E C O L O G I C A L R E V I E W

Lake Borgne Shoreline Protection

CWPPRA Priority Project List 10
(State No. PO-30)

95% Ecological Review

Figure 2. Depiction of features and “weak” or “strong” soil reaches along the Bayou Dupre Reach and proposed structures (LDNR, CED 2005).

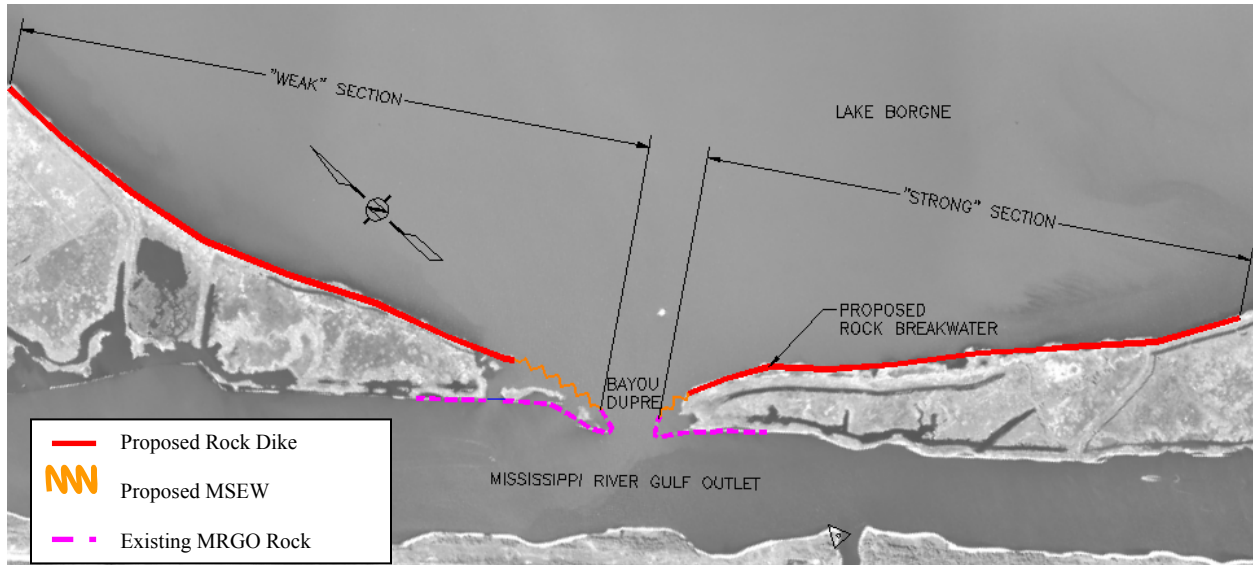
The geotechnical investigation revealed that rock could not be placed at the initially preferred alignment along the -5 foot contour nor would the soils along the -2-foot contour (secondary alignment) support the weight of rock with the exception of a few stretches due to high settlement rates. A second geotechnical investigation ensued to determine if onshore placement was more feasible. Capozzoli and Associates, Inc. (2003) recommended that the rip-rap material be placed at the marsh edge where the soil bearing capacities were more suitable and minimal settlement would occur. To further minimize settlement and construction costs, the alignment of the structure was moved onshore (except for areas where the structure was to tie into the rock structures along the MRGO). The second investigation resulted in the area soils being

classified as “strong” or “weak” based on their bearing and shearing strengths and their slope stabilities (Figures 2 and 3).

Figure 3. Depiction of the “weak” and “strong” stretches along the Shell Beach reach (LDNR, CED 2005).

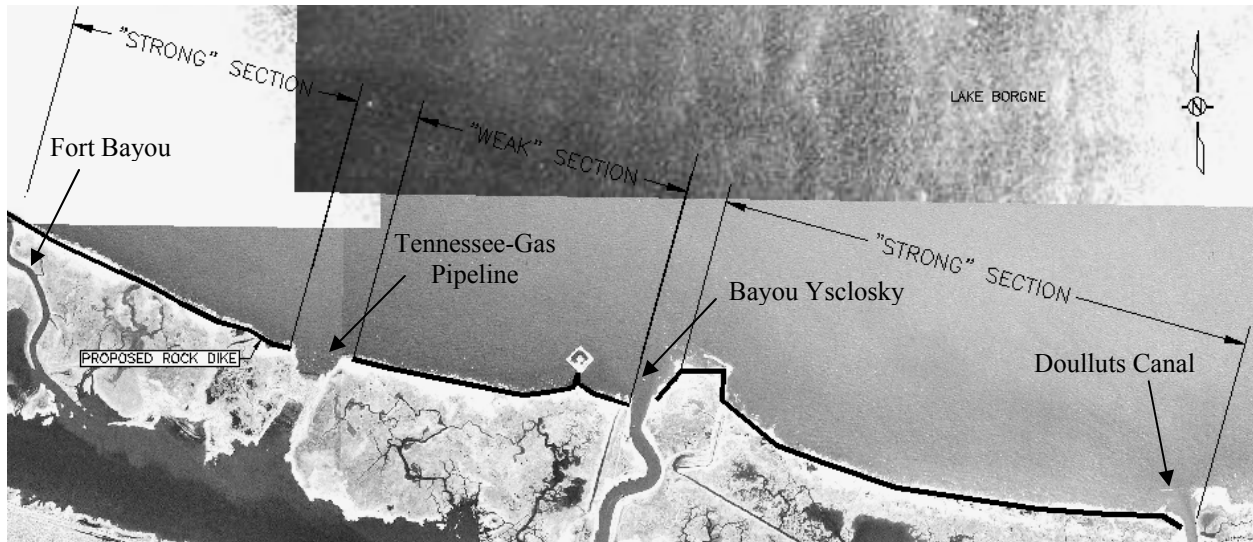
The reach to the west of Bayou Dupre along with the reaches of Shell Beach from Fort Bayou eastward to the Tennessee Gas Pipeline and from Bayou Ysclosky eastward to Doulluts Canal are all classified as “strong” and would require only one construction lift (top elevation +4.0 feet NAVD 88) to maintain an elevation of +3.0 feet NAVD 88 throughout the duration of the project life. The reach to the east of Bayou Dupre along with a reach of Shell Beach from the Tennessee Gas Pipeline eastward to Bayou Ysclosky are classified as “weak”. These reaches would require a phased construction approach.

Figure 4. Typical section of the rock structure along “strong” soil reaches (LDNR, CED 2005).

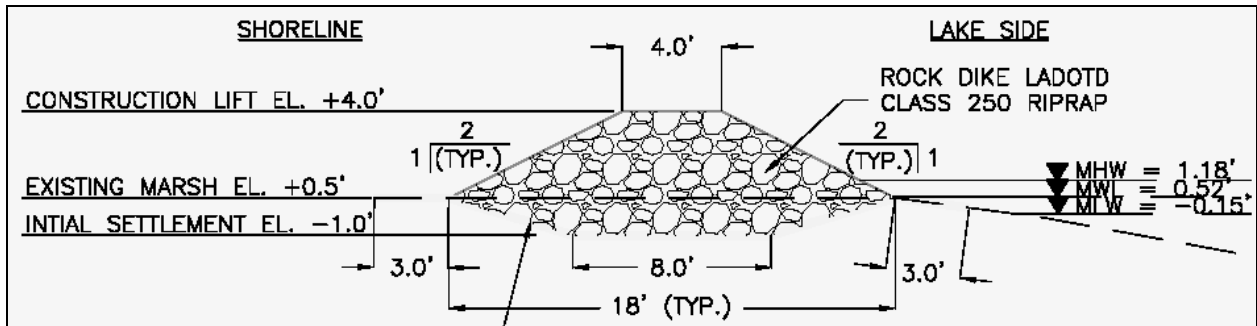
The final construction dimensions of the rock structures on the “strong” soils (Figure 4) would have a crest width of 4 feet, with 1(V):2(H) side slopes, and top elevation of +4.0 feet NAVD 88. Those dikes would settle approximately 2 inches immediately after construction. The structure is estimated to only experience an additional 10 inches of settlement over the remainder of the 20-year project life. The dikes would not settle below the 90th percentile wave height (+2.0 feet NAVD 88) for the duration of the project life nor would the structures settle lower than the one foot freeboard (elevation +3.0 feet NAVD 88) that would provide added protection in the event of a storm or unexpected increased settlement.

Figure 5. Typical section of the rock structure along “weak” soil reaches (LDNR, CED 2005).

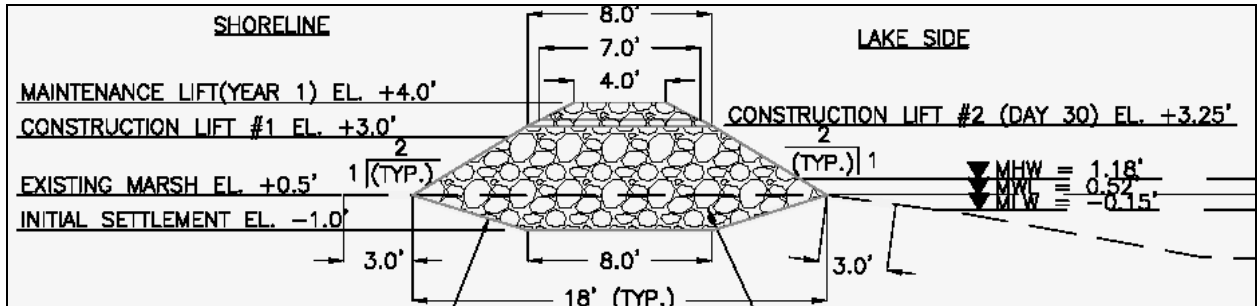
The first construction lift of the rock on the “weak” soils (Figure 5) would have dimensions of an 8-foot crest width, 1(V):2(H) side slopes, and top elevation of +3 feet NAVD 88. It is estimated that those dikes would settle approximately 1.5 feet in the first 30 days. That abrupt amount of settlement would place the structures below the 90th percentile design wave height (+2 feet NAVD 88) requiring additional lifts. The second construction lift would have dimensions of a 7-foot crest width, 1(V):2(H) side slopes, and top elevation of +3.25 feet NAVD 88. The second construction lift would settle an additional 1.25 feet by project year 1. At project year 1, a maintenance lift would be applied that would raise the dike to an elevation of +4 feet NAVD 88. The final dimension of the maintenance lift would have a 4-foot crest width, 1(V):2(H) side slopes, and a top elevation of +4 feet NAVD 88. The dike would remain at an elevation higher than the 90th percentile design wave height beyond project year 20 but would settle below the one foot of freeboard (elevation +3 feet NAVD 88) during project year 8.

Figure 6. Cross-sectional depiction of MSEW (LDNR, CED 2005).

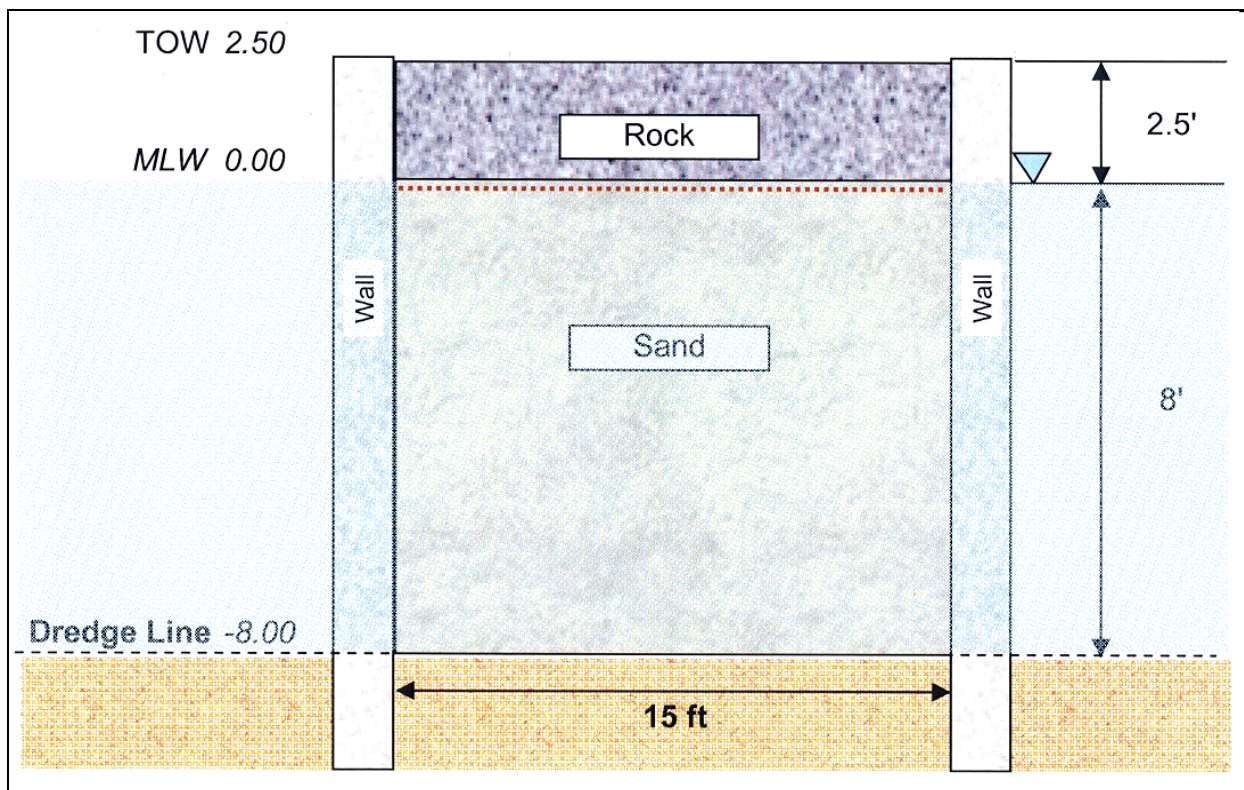
Mechanically stabilized earthen walls (MSEW) would be used to connect the rock structures placed onshore of the lake with existing structures along the MRGO. The structures would be used in deep water areas of the project where rock placement was not feasible. The open-water areas in question are at the ends of the Bayou Dupre project reaches where the bayou connects the lake to MRGO. MSEW’s consist of two steel sheetpile panels driven to depths of 30-40 feet. The panels would be held together with tie rods and walers and would then be in-filled with sand that would be capped with rock up to a top elevation of +2.5 feet NAVD 88 (Figure 6 [LDNR, CED 2005]). This elevation is only 0.5 feet higher than the 90th percentile design wave height, but very little settlement of the structure is expected once the sand has been wet and reaches equilibrium. Weep holes would be drilled into the structure at elevation 0.0 feet NAVD 88 to reduce the effects of shearing forces and allow water to passively impact the structure.
